May 28, 2003  
NL-03-093

SUBJECT: Indian Point Nuclear Generating Unit No.3  
Docket No. 50-286  
**Proposed Changes to Technical Specifications:  
Pressure-Temperature and Overpressure Protection  
System Limits for Up To 20 Effective Full Power Years**

This amendment request seeks to revise several pages of Section 3.4, including figures, of the Indian Point 3 Technical Specifications. Specifically, the Pressure-Temperature (P/T) and Overpressure Protection System (OPS) limits are being revised from 16.17 Effective Full Power Years (EFPYs) to 20 EFPYs. The previous limit of 16.2 EFPYs was approved by the NRC in Amendment 202 (Reference 1) and was adjusted to 16.17 EFPYs, in Amendment 213 (Reference 2) to support the Appendix K uprate effort. The expiration date reduction was due to higher power rating, not due to a change in vessel embrittlement methodology. An explicit list of changes is contained in Section 2.0 below.

Figure 3.4.12-2: Pressurizer Limitations for OPS Inoperable, 16.17 EFPPY  
(Up to one charging pump capable of feeding the RCS)

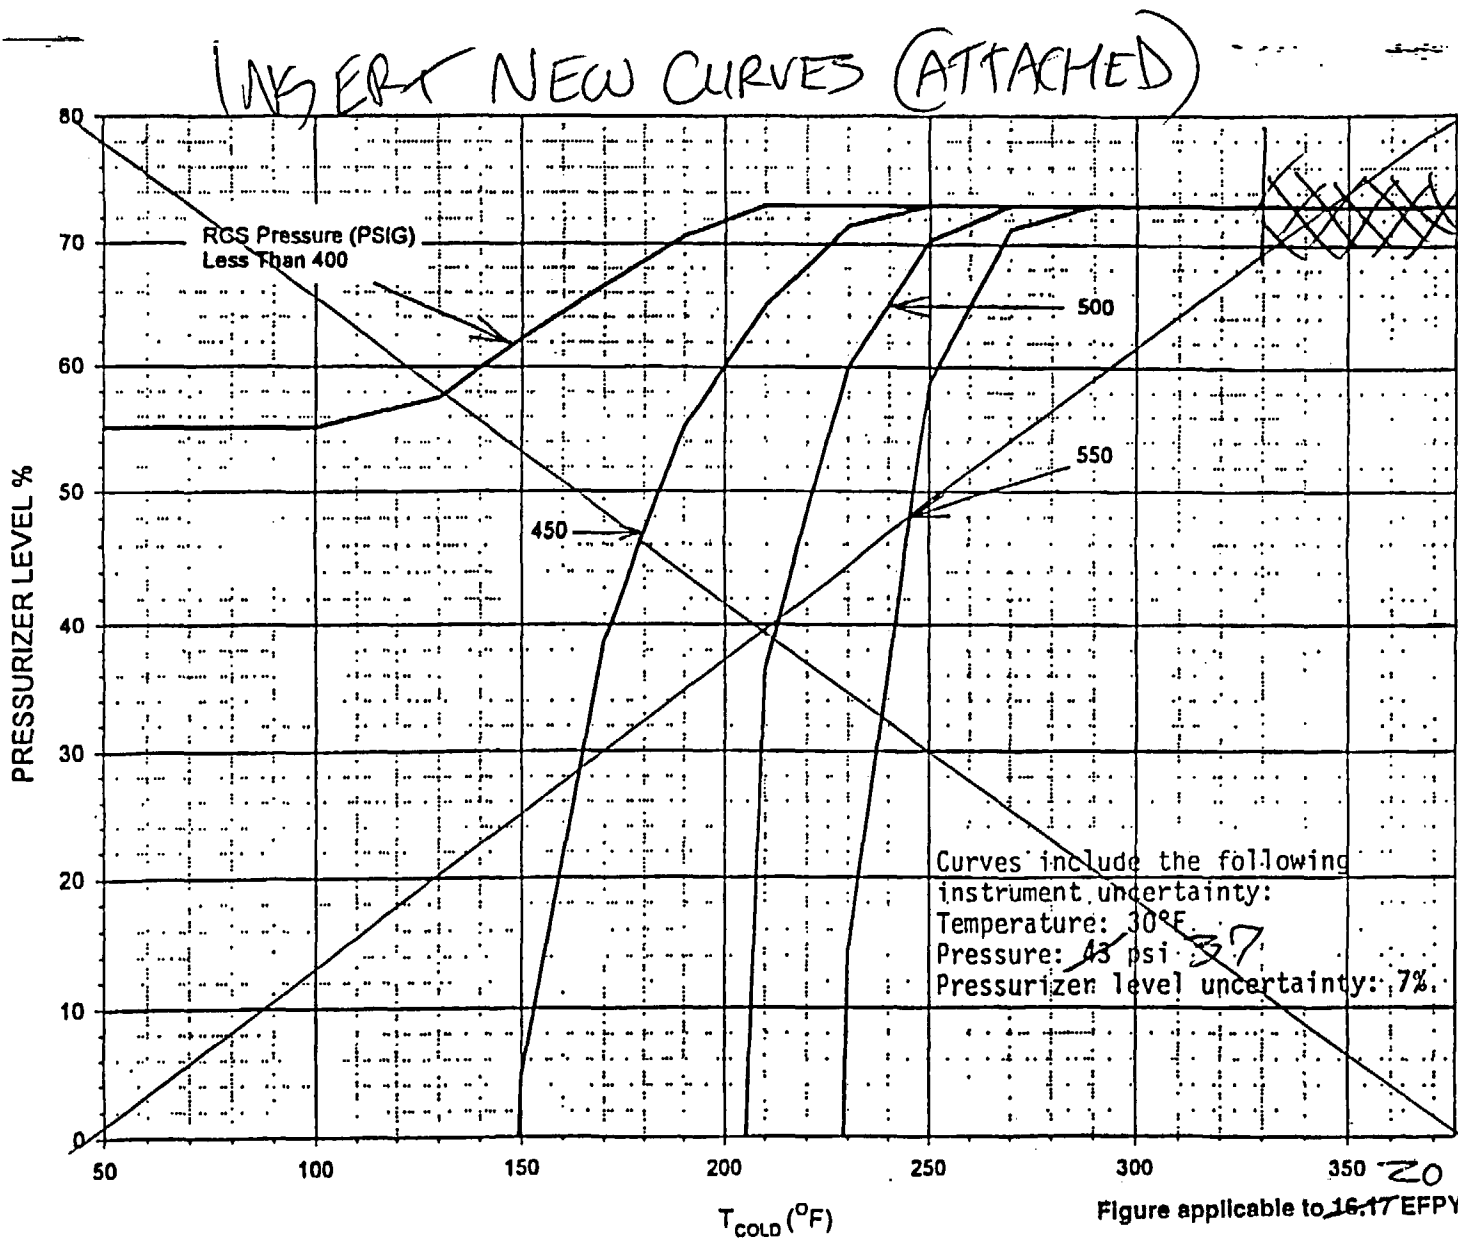
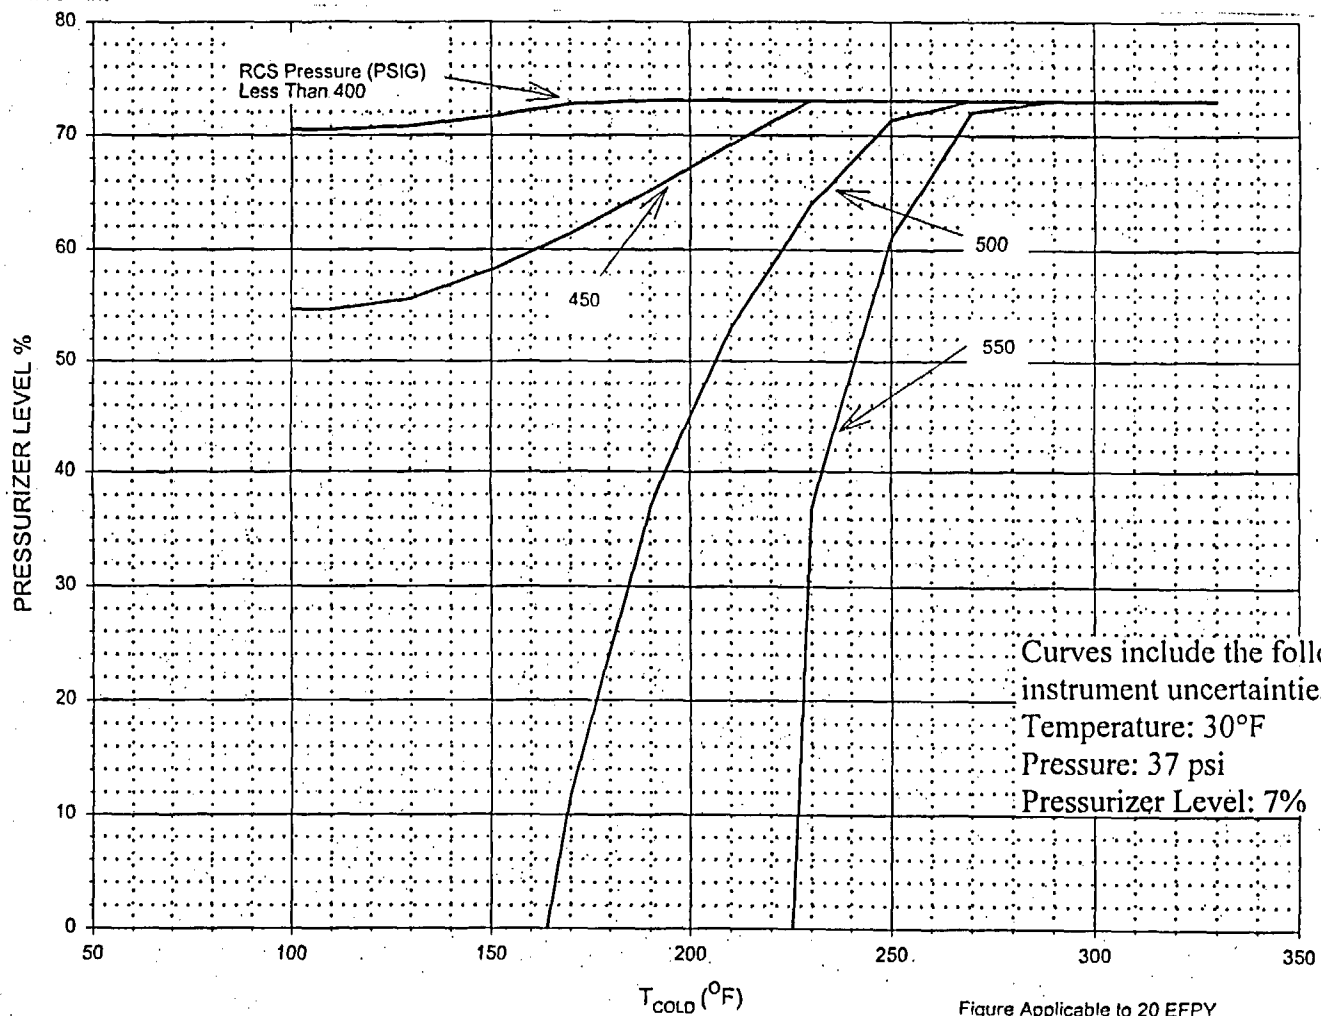
The proposed amendment will revise the curves, and, the titles of both figures to read:

The proposed amendment will revise both Figures to read:

Figure Applicable to 20 EFPY

Figure 3.4.12-2: Pressurizer Limitations for OPS Inoperable, 20 EFPY  
(Up to one charging pump capable of feeding the RCS)

Figure 3.4.12-3: Pressurizer Limitations for OPS Inoperable, 16.17 EFPY  
(Up to three charging pumps and/or one safety injection pump capable of feeding RCS)

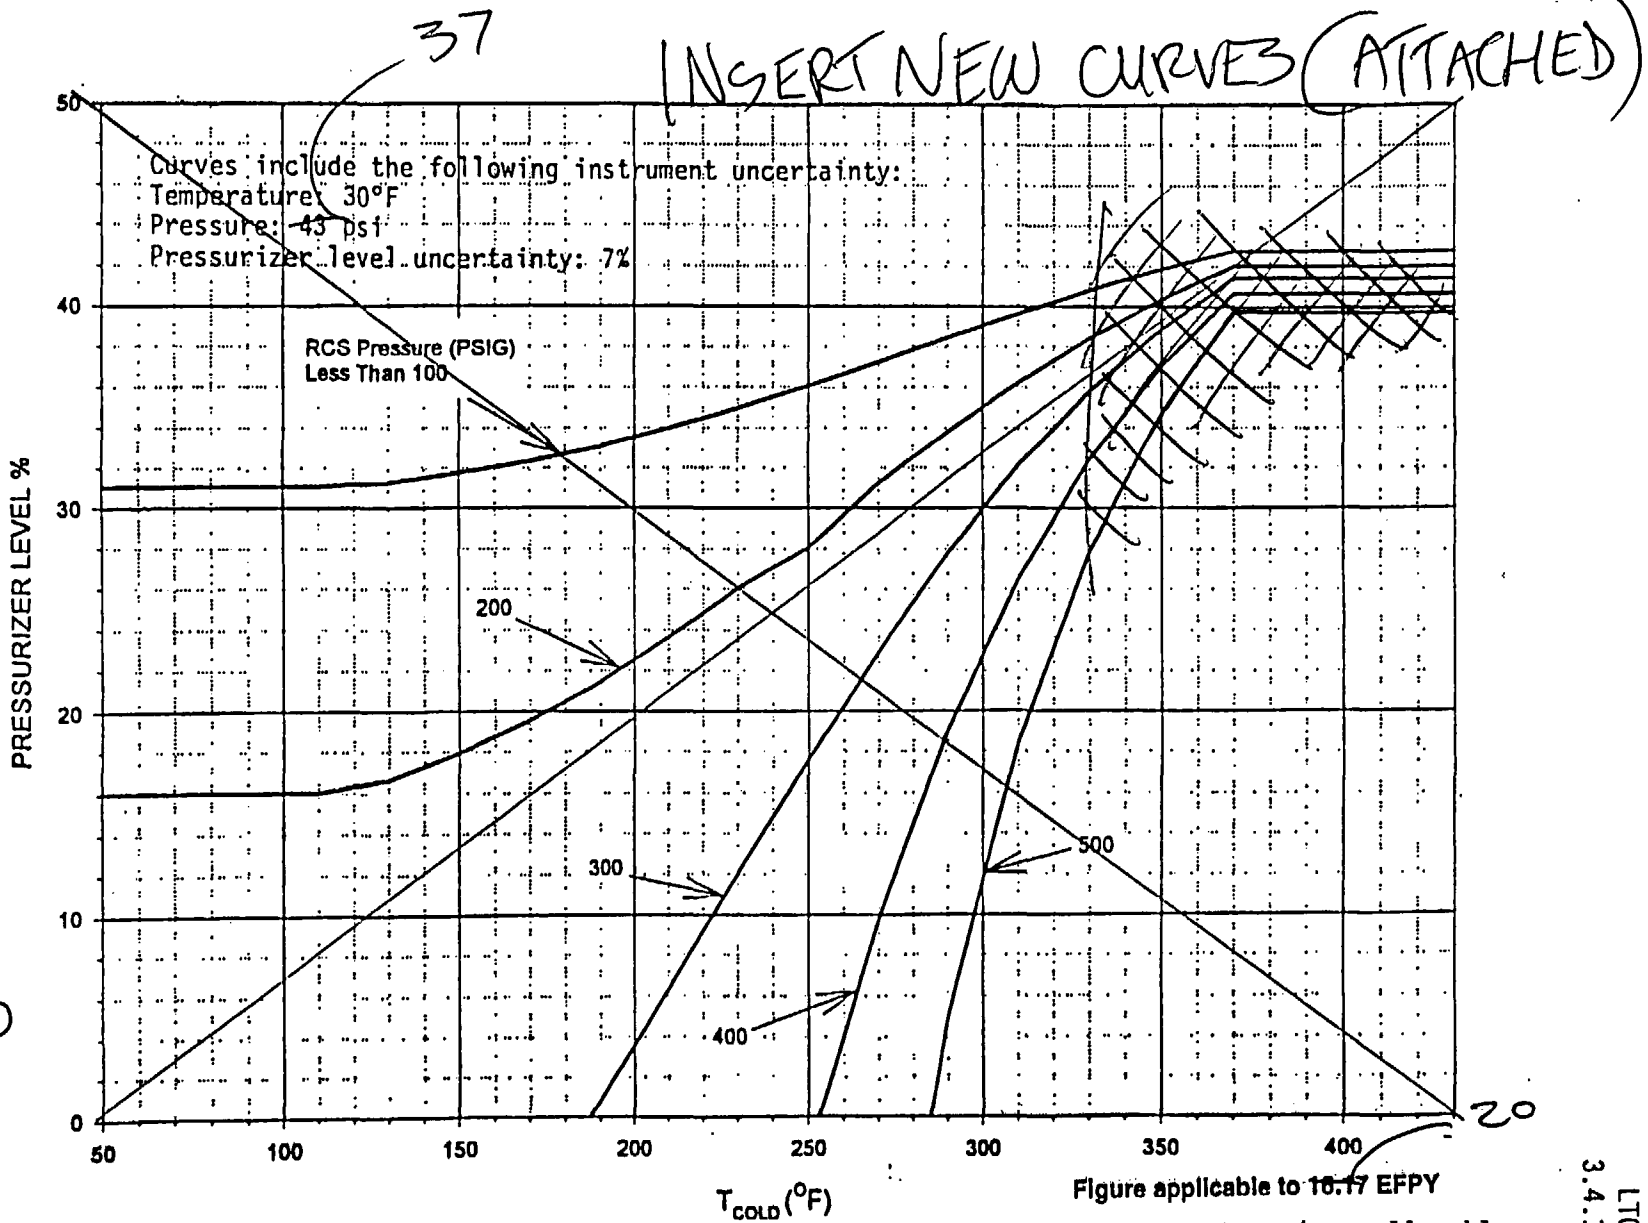
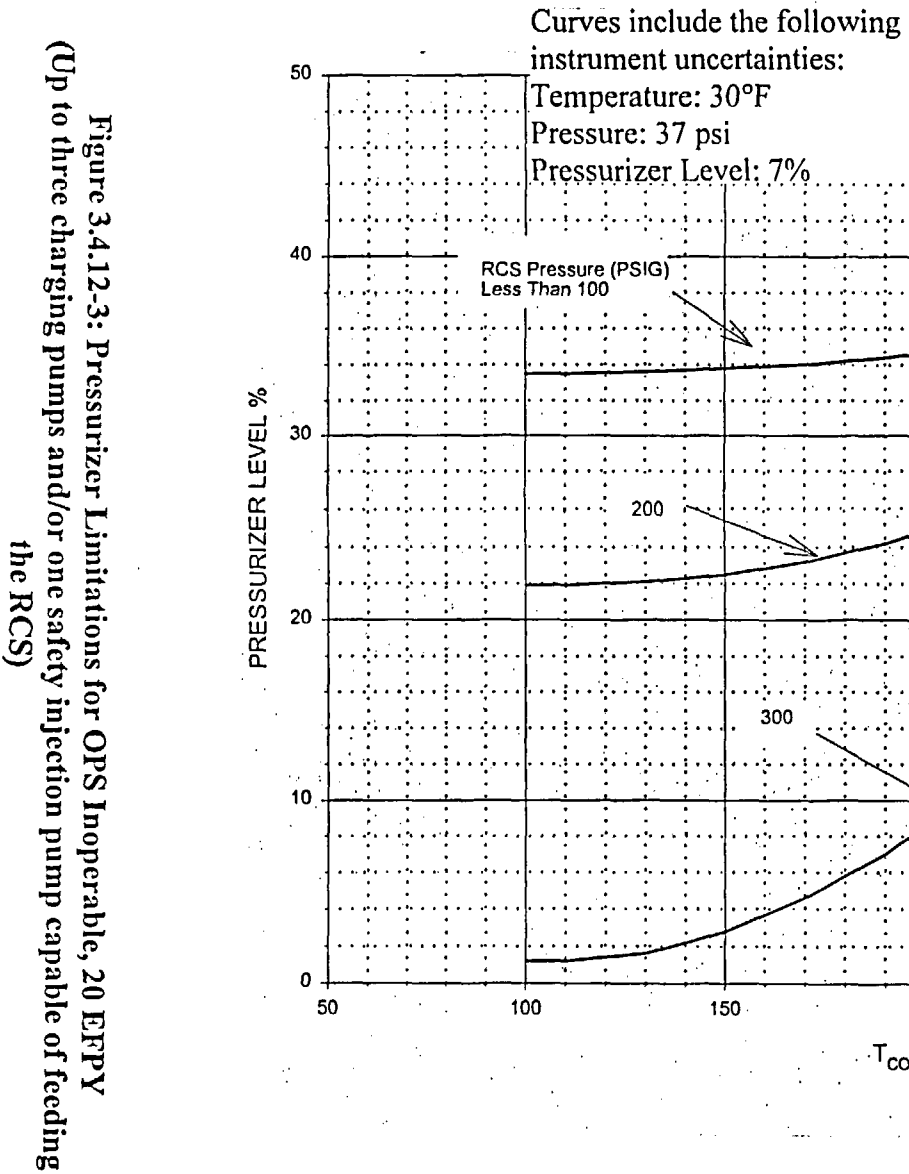
The proposed amendment will revise both Figures to read:

Figure Applicable to 20 EFPY

Figure 3.4.12-4: Secondary Side Limitations for RCP Start  
With Secondary Side Hotter than Primary Side, 46-17-EFPY

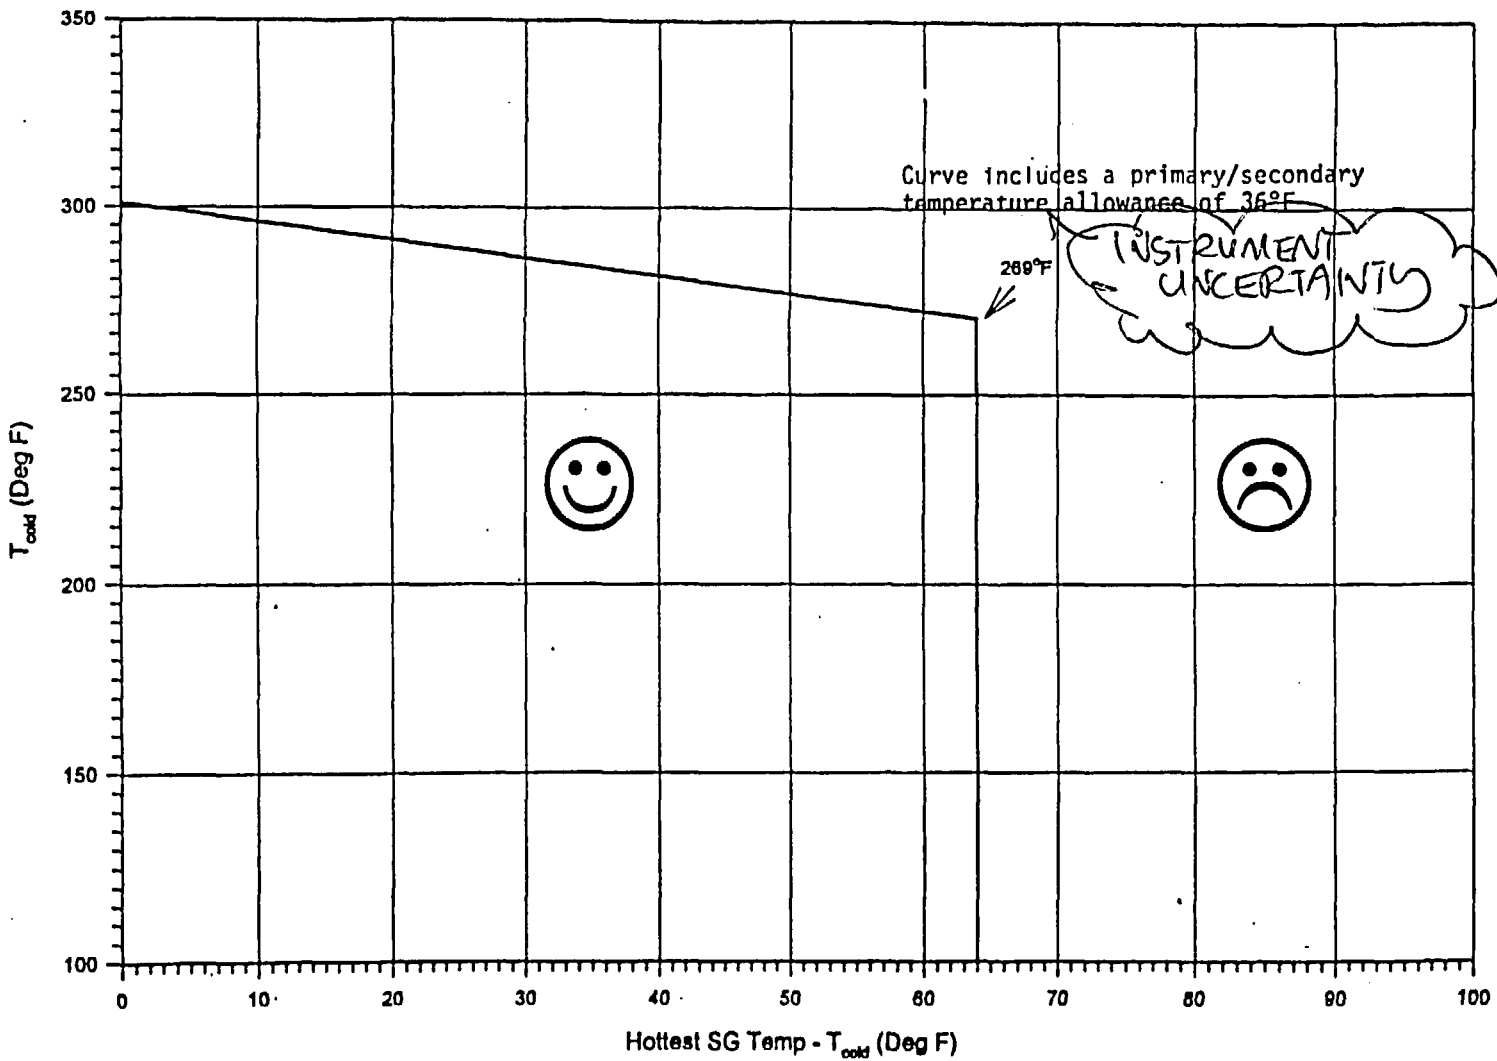
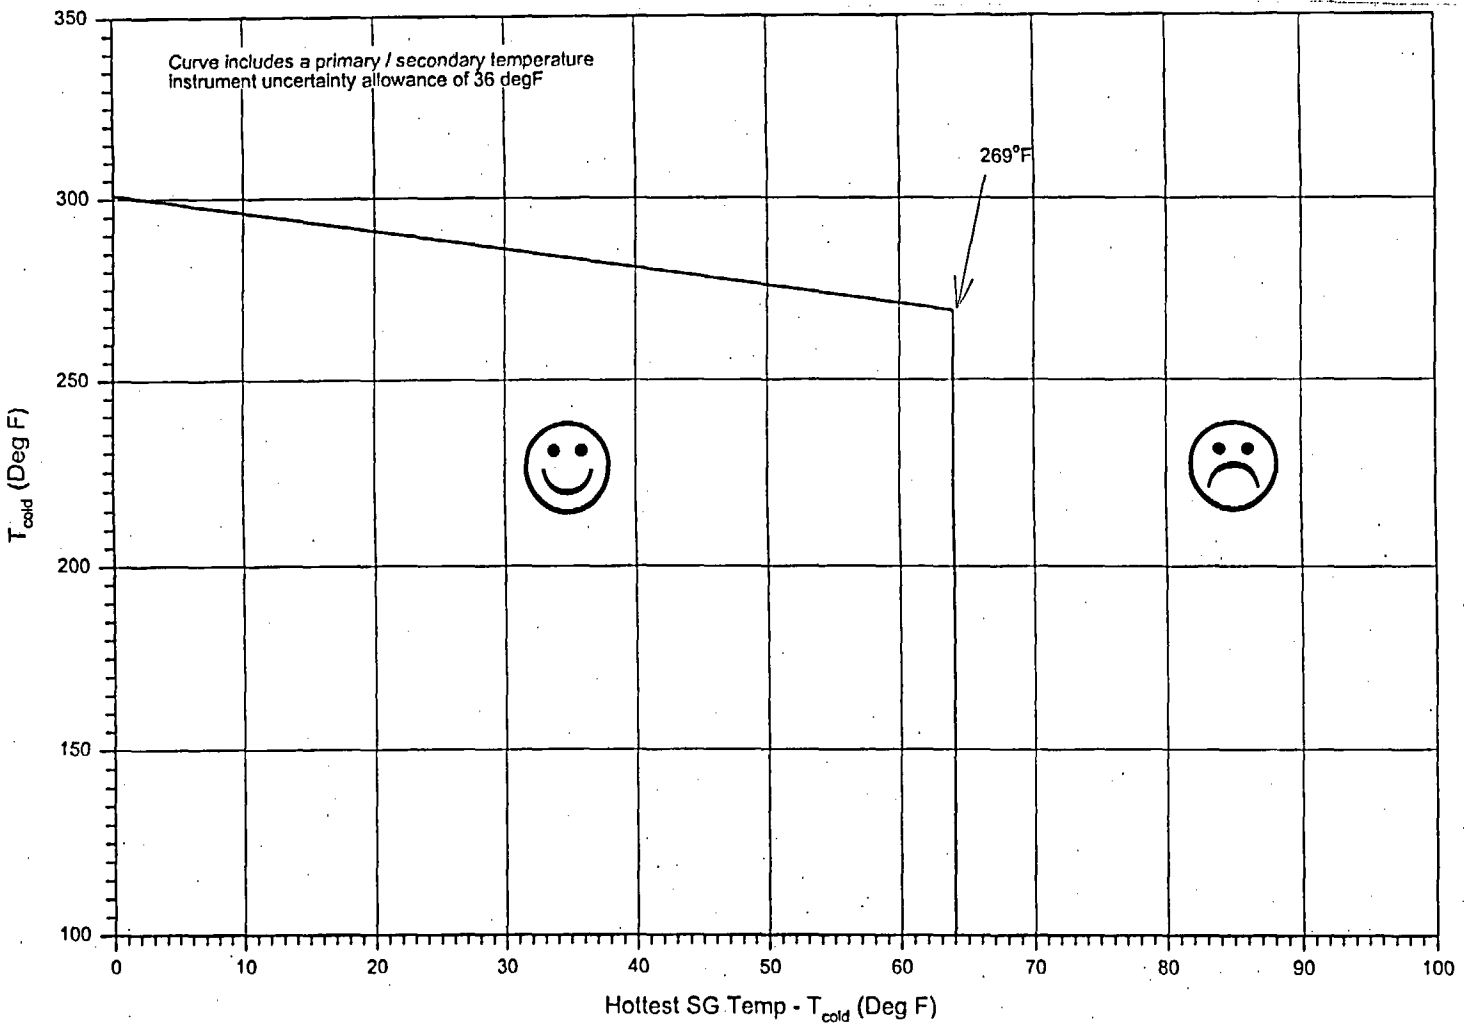
- I. Indian Point 3 Technical Specification Figure 3.4.12-4, is entitled, in part:

The proposed amendment will revise the curve and the title of Figure 3.4.12-4 to read:

Also, Figure 3.4.12-4 has been revised to read:

Figure 3.4.12-4: Secondary Side Limitations for RCP Start with  
Secondary Side Hotter than Primary Side, 20 EFY
